## Product Change Notice (PCN)

**PCN Number:** PCN-0210042R-01

Product(s) Affected: MSIM-3-C

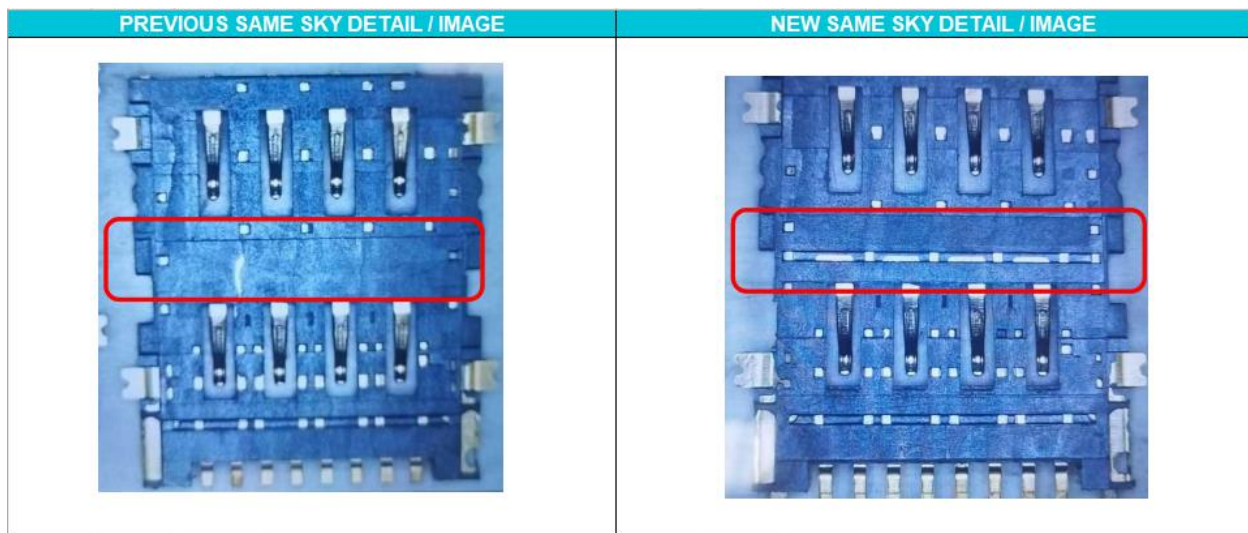
Description of Change: Pressure relief holes have been added to the bottom of the product. This addresses irregular terminal protrusion, ensuring a uniform and consistent product appearance, effectively reducing defects in the injection molding process.

Dimensions remain unchanged; this modification does not affect the product's functionality.
